PLANNING COMMISSION AGENDA

Title: Final Site Plan - 940 North 1250 West - Hogan Steel Fabrication & Cabinet Shop - ADMINISTRATIVE DECISION

APPLICATION: REQUEST FOR FINAL SITE PLAN APPROVAL

FINAL SITE PLAN SUBMITTAL REVIEW – CZC 12.21.110(e)

24 DUMPSTER ECLOSURE
ASS01 NOT TO SCALE

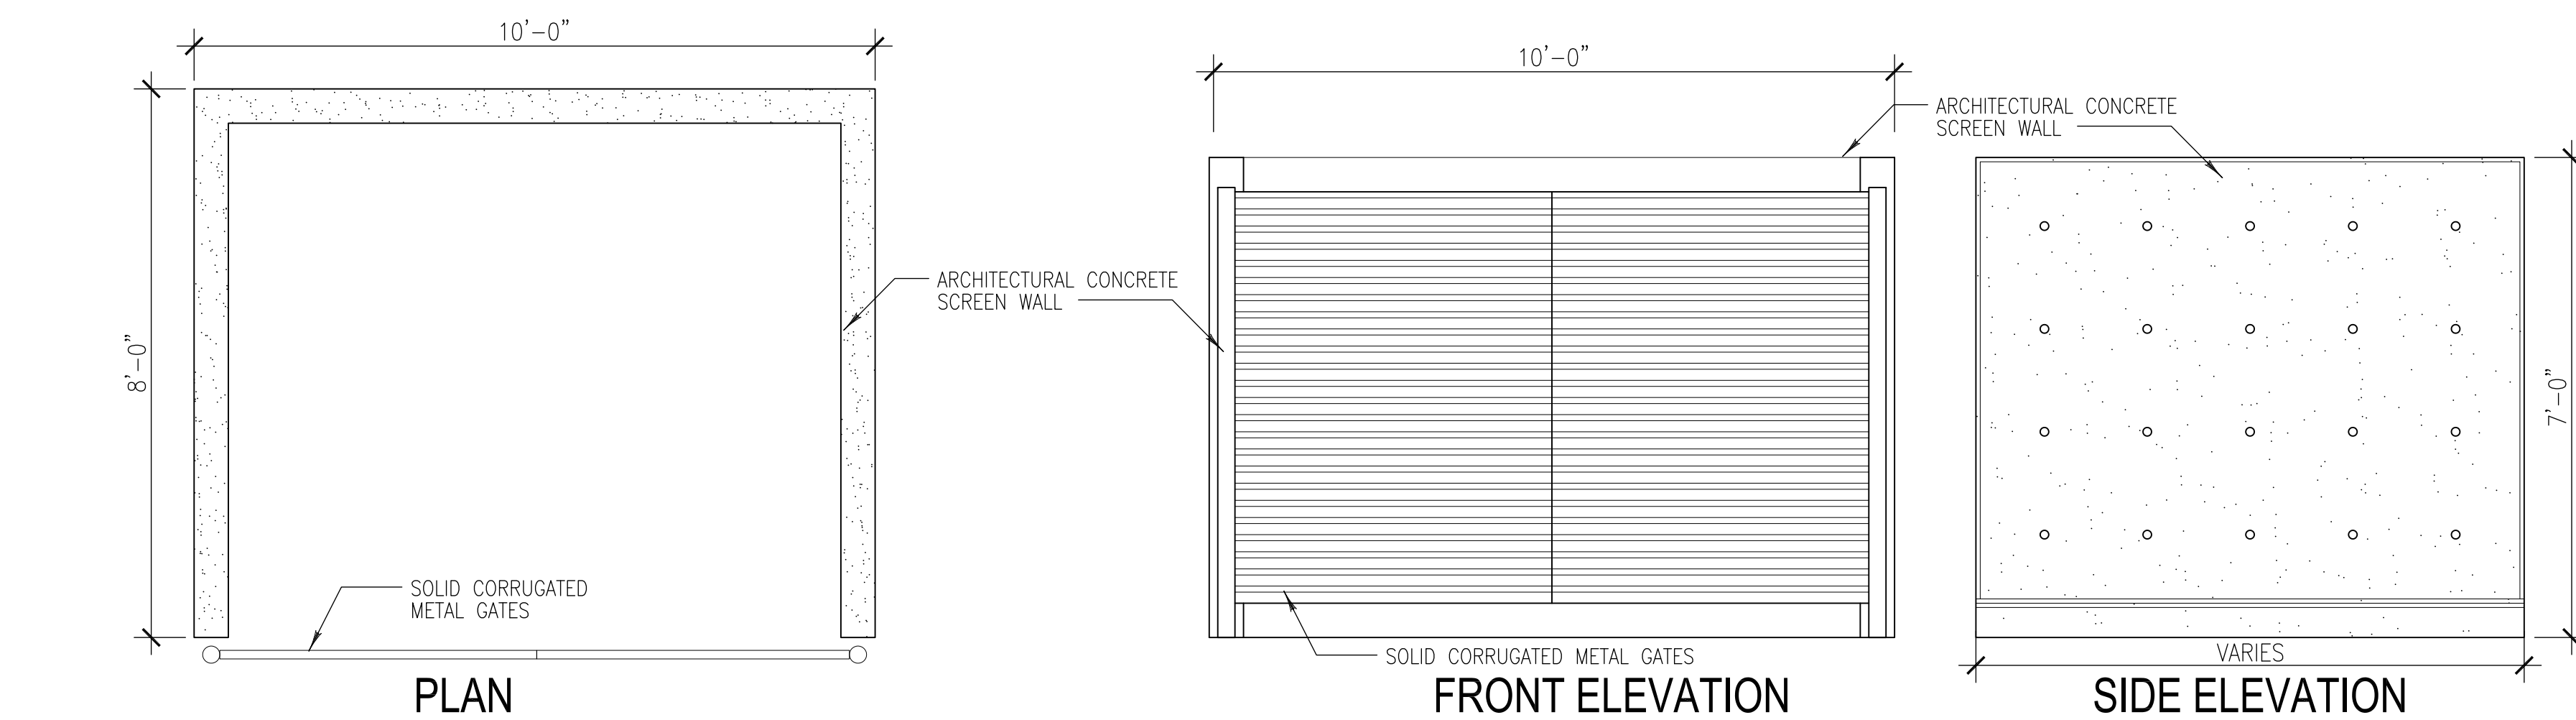
The Final Site Plan now depicts dumpsters and enclosure for compliance with the design expectations of CZC 12.51.110(b).

17 CONCEPT MONUMENT SIGN (MAXIMUM ENVELOPE) BY OWNER
ASS01 NOT TO SCALE

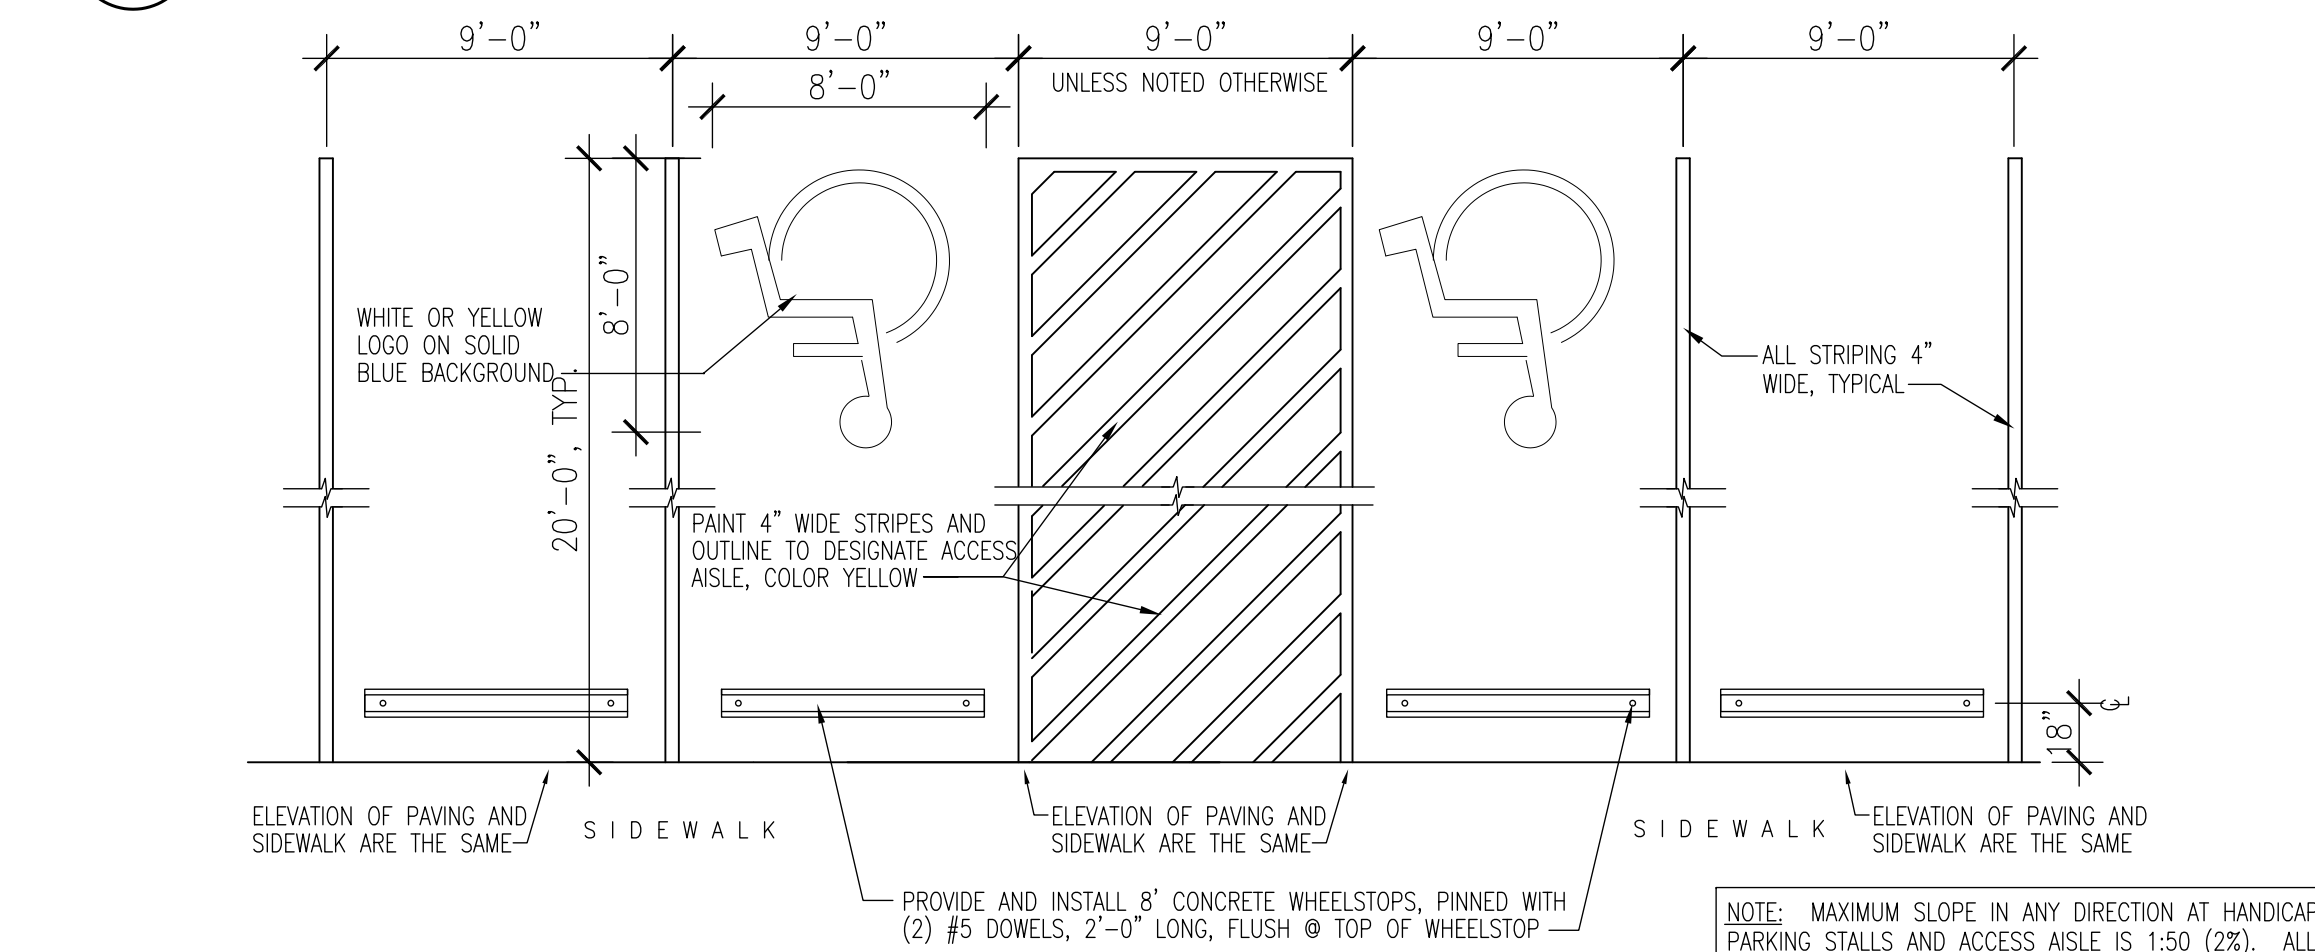
- **Signs, Chapter 12-54** - All signage requires a separate permit and must be reviewed by zoning staff for approval at the time a sign permit application has been submitted following Chapter 12-54 of the Zoning Ordinance. The Final Site Plan submittal does not depict any placement location for allowable monument signs.

LANDSCAPE
PLAN

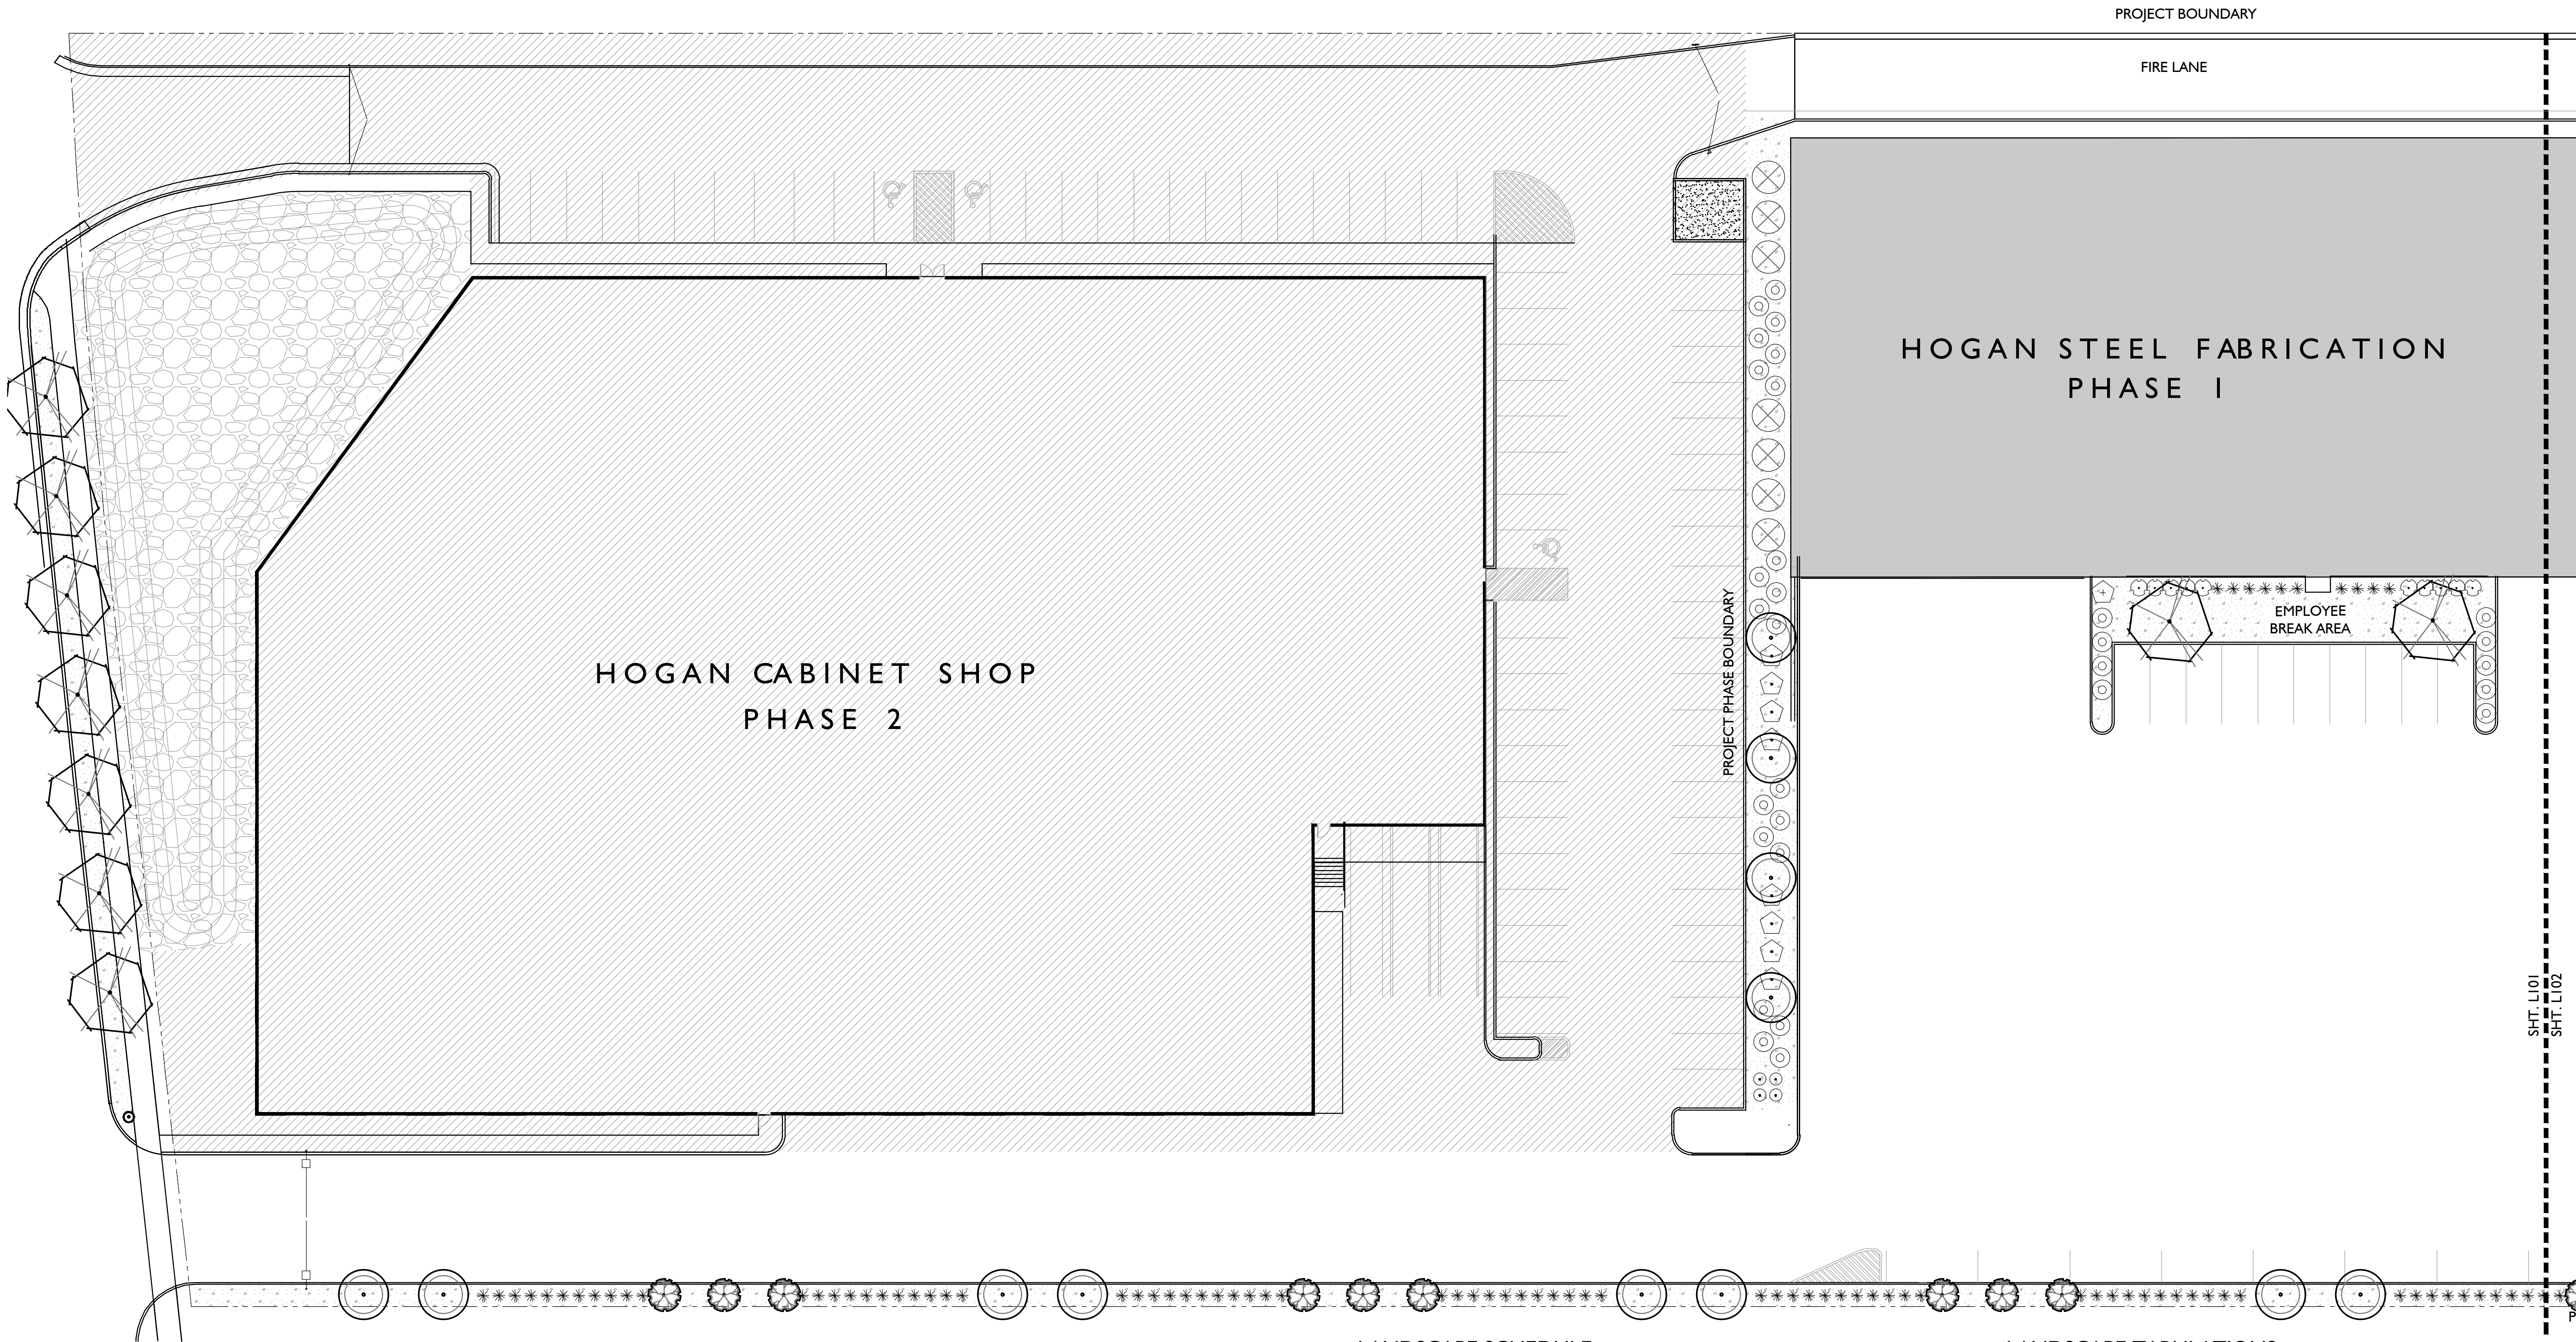
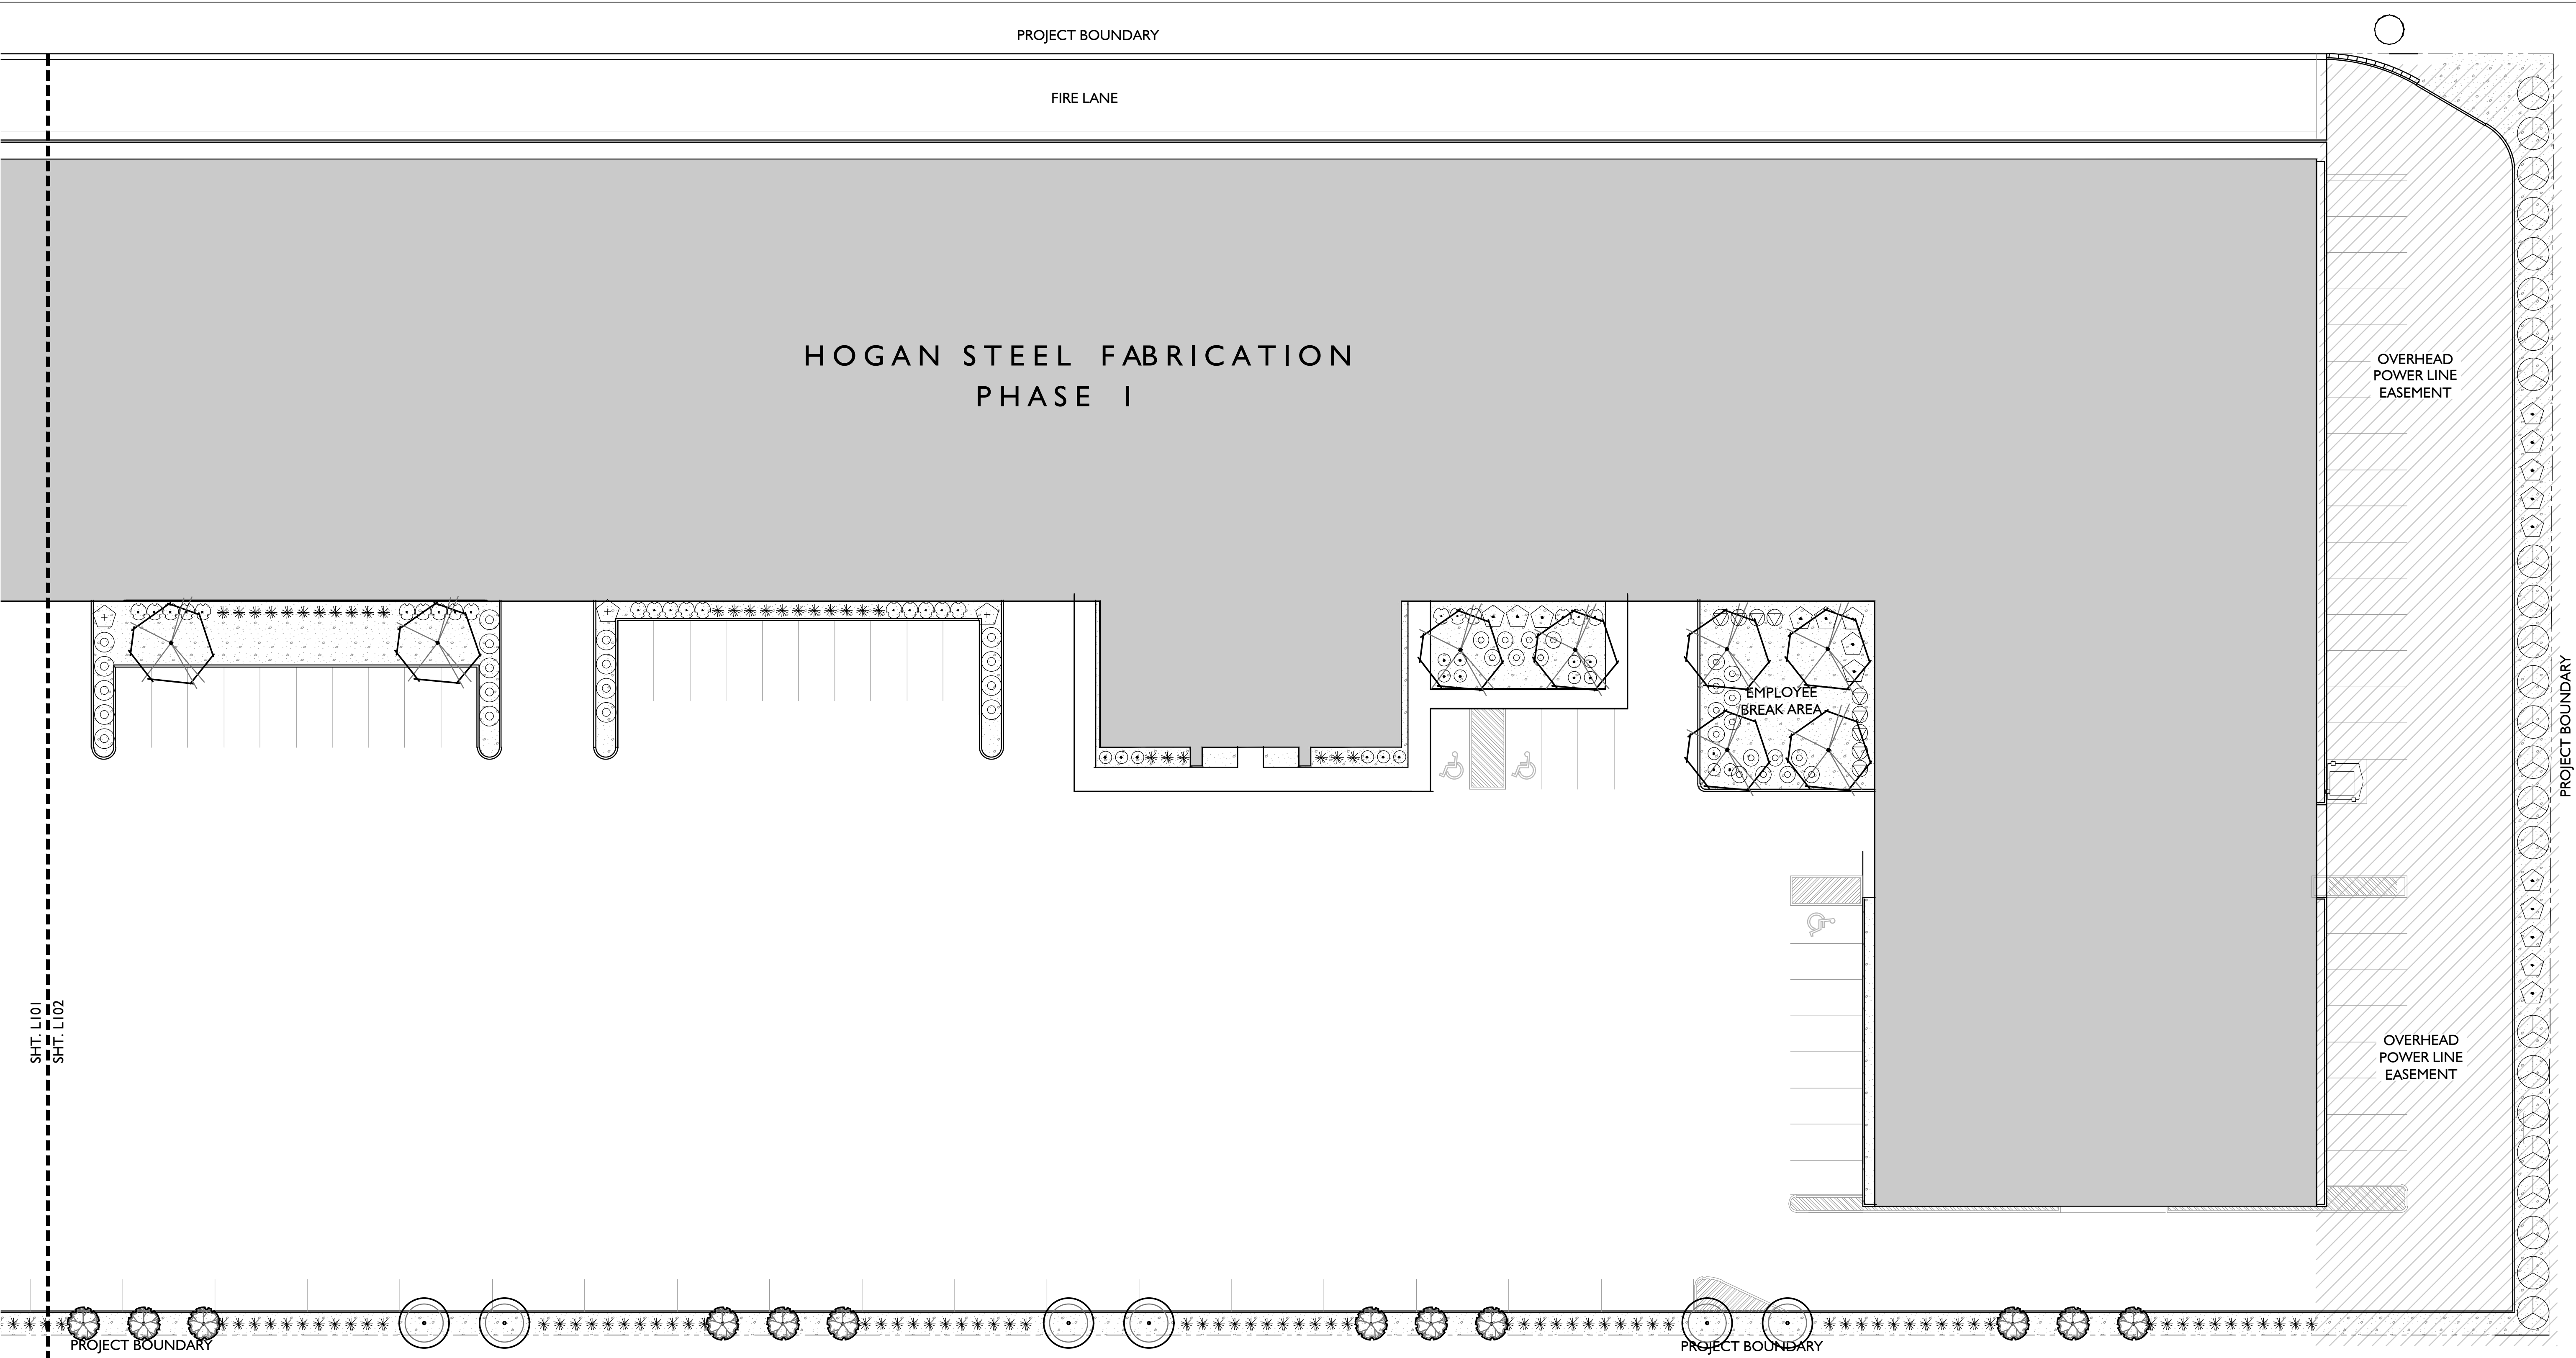
- **Parking, Chapter CZC 12-52** – The parking schedule indicates that general manufacturing use would require 161 parking stalls, which have been depicted on the Final Site Plan.
- **Landscaping, Chapter 12-51** – The applicant has submitted an Final Landscaping Plan. However, the plan only addresses a portion of the development. The Landscaping Plan is missing or incomplete, as follows:

- c. *Confirm compliance with the landscaping plantings of trees, shrubs, and internal parking lot landscaping of 5%. A Licensed Landscape Architect shall stamp Landscape Plan.*

- c. *Confirm compliance with the landscaping plantings of trees, shrubs, and internal parking lot landscaping of 5%. A Licensed Landscape Architect shall stamp Landscape Plan.*
